## **Chu, Eva, Public Health, EHS**

**From:** Fletcher, Curtis[SMTP:Curtis.Fletcher@oldcastleprecast.com]  
**Sent:** January 29, 2001 2:12 PM  
**To:** 'Chu, Eva, Public Health, EHS'  
**Subject:** RE: 1901 Isabel Ave, Livermore, CA

**From:** Chu, Eva, Public Health, EHS [mailto:EChu@co.alameda.ca.us]  
**Sent:** Tuesday, January 23, 2001 4:45 PM  
**To:** 'curtis.fletcher@oldcastleprecast.com'  
**Cc:** Weston, Robert, Public Health, EH  
**Subject:** 1901 Isabel Ave, Livermore, CA

NAME OF FACILITY: Utility Vault Co SITE ADDRESS: 1901 Isabel Ave

Appendix E

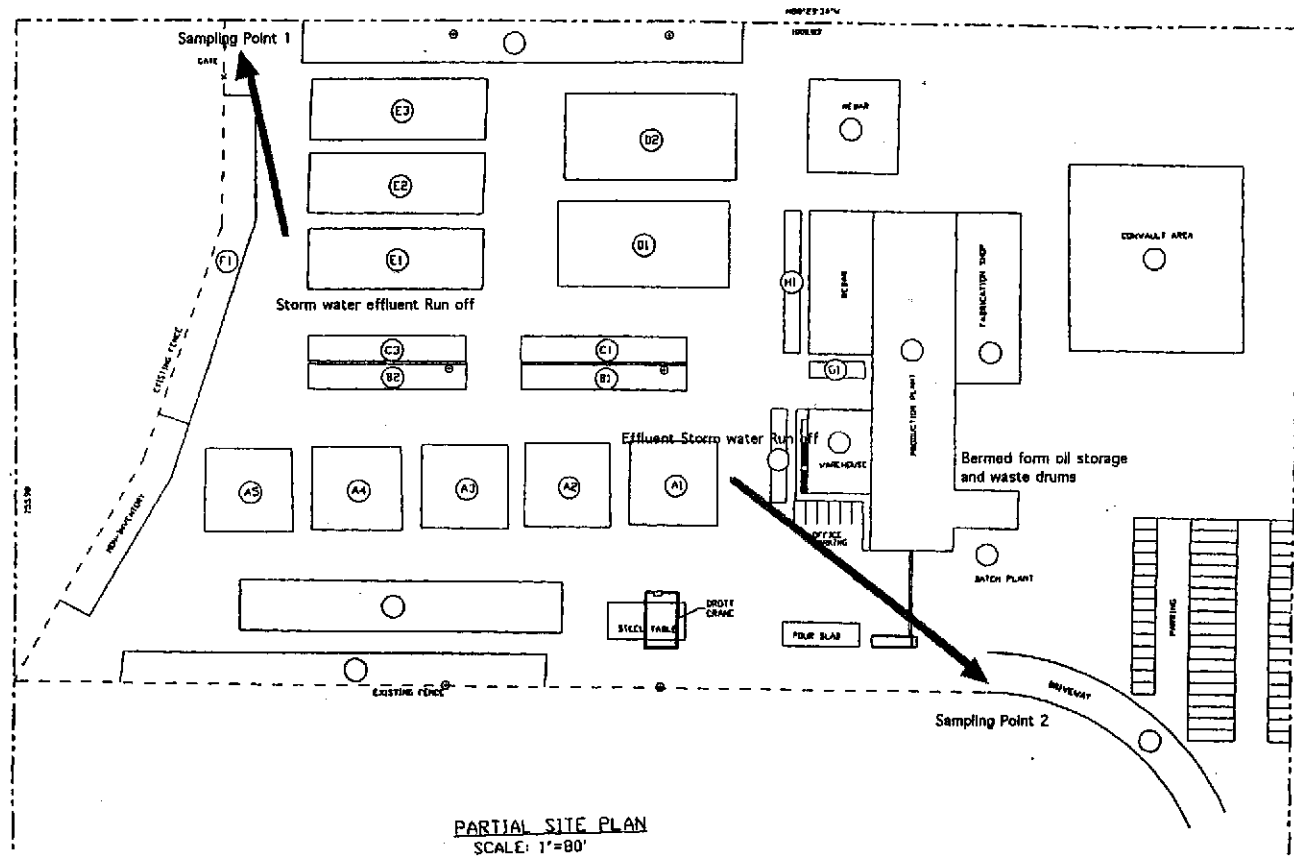
I would recommend collecting the following soil samples. (in yellow)

Photo 22 indicates vault - pressure wash pit - recommend 2 samples  
one beneath <sup>vault</sup> pit one in leach field area.

soil  
● = recommended samples  
i:\hmbp\formlappew61

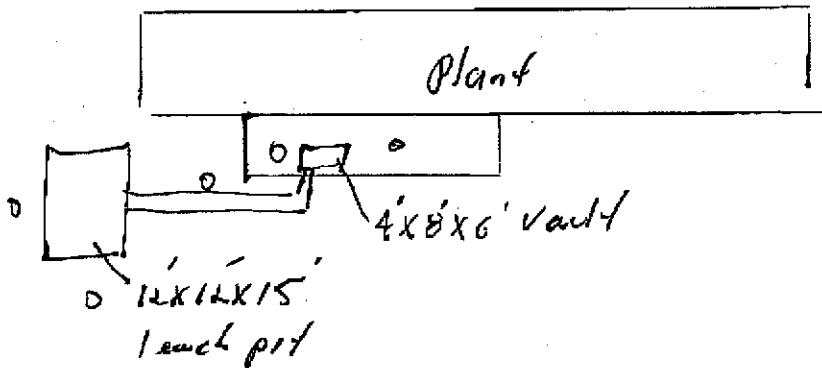
Thank you for your phone conversation. After finding the person that actually installed the unit, I'm getting a different version of its construction & history. The last Safety Coordinator gave me a different story. A truck driver that had experience with septic tank systems installed the oil water separator in 1990. I've included a drawing of how the system is arranged.

As you can see from the drawing there are two parts to the system. The first being the oil water separator & the second being the leach area for the water run off. The line going from the vault to the leach area was about half way up the side of the separator. I've been told the three sediment baskets are still in the vault. I was also told the baskets were full of sediment (having never been cleaned) when the vault was filled with dirt & concrete blocks. Previous people said the water was allowed to evaporate before the vault was filled.

Top View

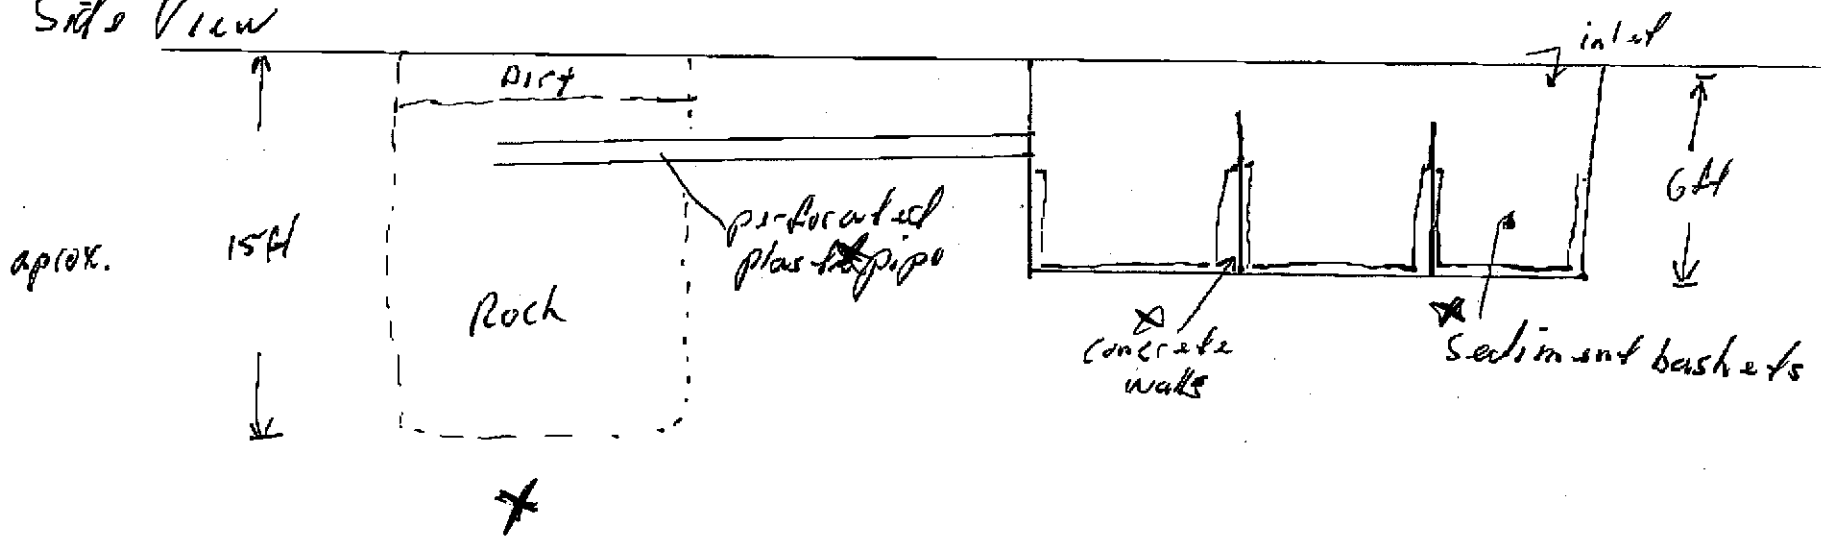
I discussed the Scope of Work you submitted for the above referenced site with Rob Weston. We both agreed that the work proposed is not adequate to characterize potential soil contamination at the site.

This office would also like to see soil samples collected in native soil at the following locations:

- \* 1 to 2 feet below concrete vault;
- \* 1 to 2 feet below the plastic pipe (between concrete vault and leach pit);
- \* 1 to 2 feet below the leach pit.

Below is the amended Scope of Work proposal:

- 1) Remove the top dirt & concrete with a backhoe & dispose of the concrete as normal.
- 2) Cover the contents with tarp to protect from wind & rain.
- 3) Take a sample from the middle of basket one.

- 4) All material will be placed on tarp & covered.
- 5) Remove the vault.
- 6) Take sample between 1 & 2 feet below area vault was located.
- 7) Cover area with plywood to prevent any rainwater from entering.

- 8) Take sample between 1 & 2 feet below the plastic pipe (between concrete vault & leach pit)
- 9) Take a sample between 1 & 2 feet below leach pit.
- 10) Additional soil samples may be required around the leach pit. When this area is excavated, it will become evident if additional soil samples, to delineate vertical and/or horizontal extent of contamination, is necessary.
